EPC STORMWATER REVIEW COMMENTS
IN ORANGE BOXES WITH BLACK TEXT

FINAL DRAINAGE REPORT

MAYBERRY, COLORADO SPRINGS – FILING NO. 2A

SEPTEMBER 2023

FILING 2A PROP.
DRAINAGE MAP

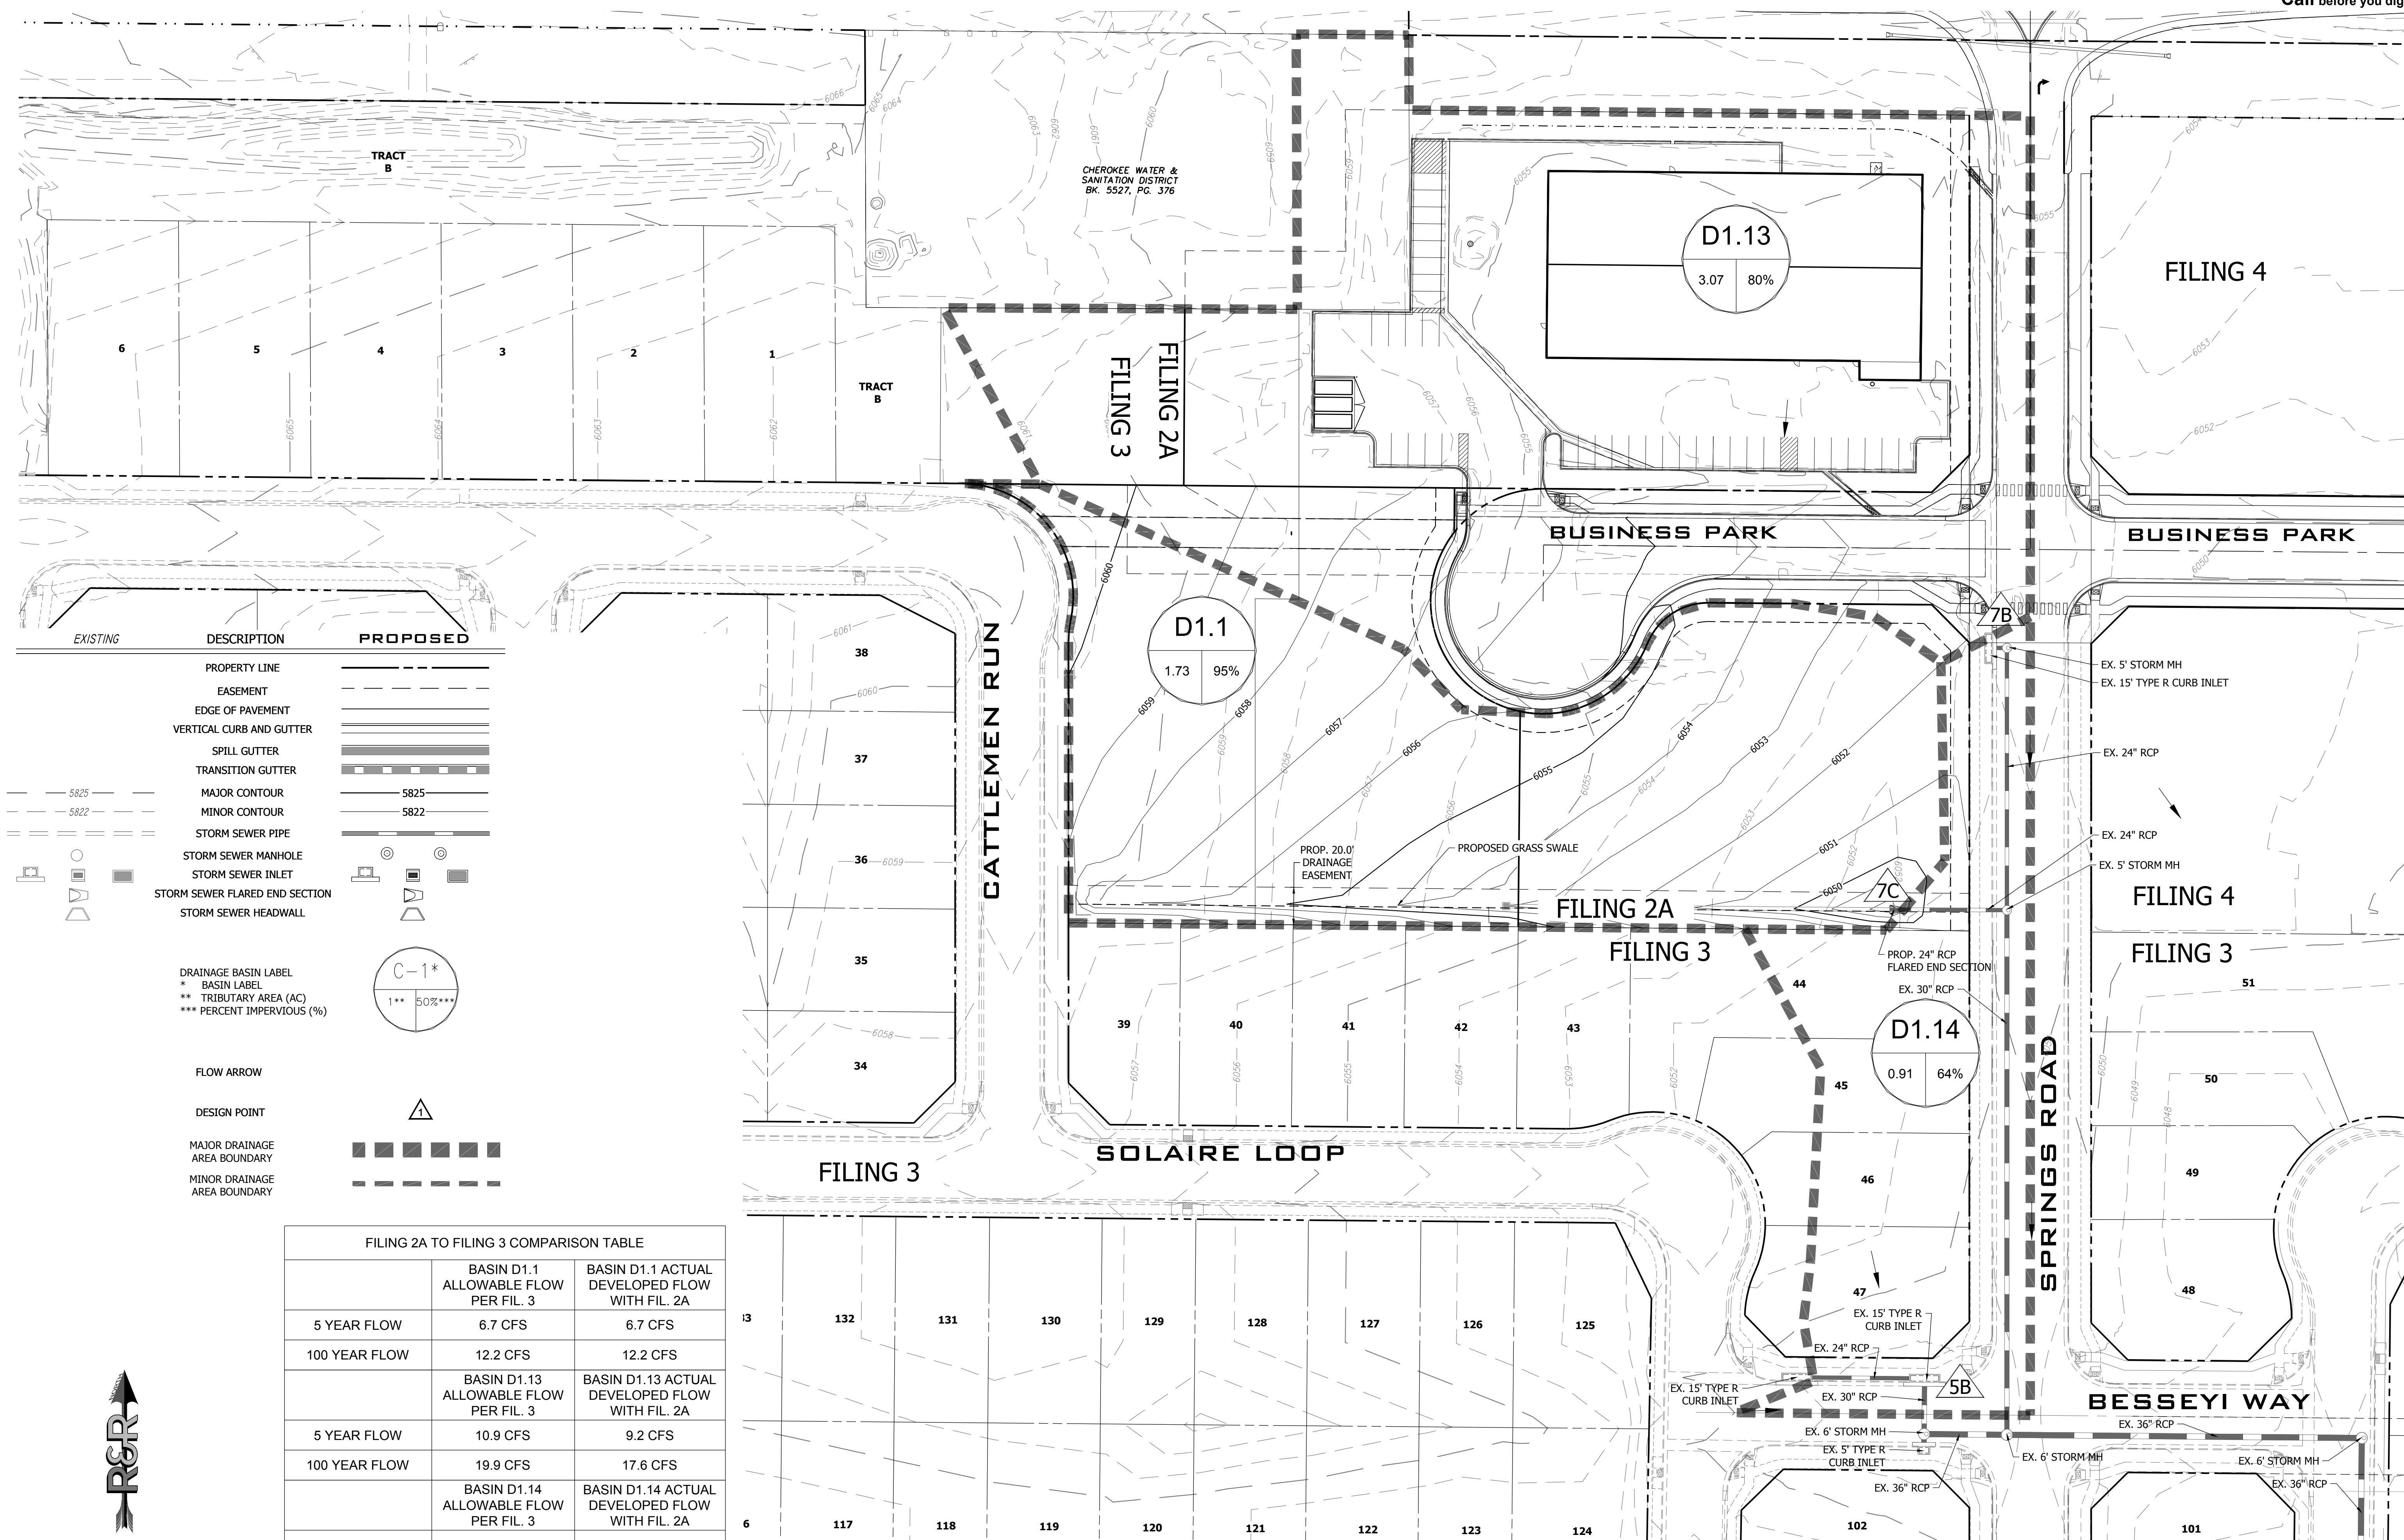
Are 100 year flows contained within the sidewalk chase? Revise to discuss if current chase is adequate to prevent overtopping on sidewalk.
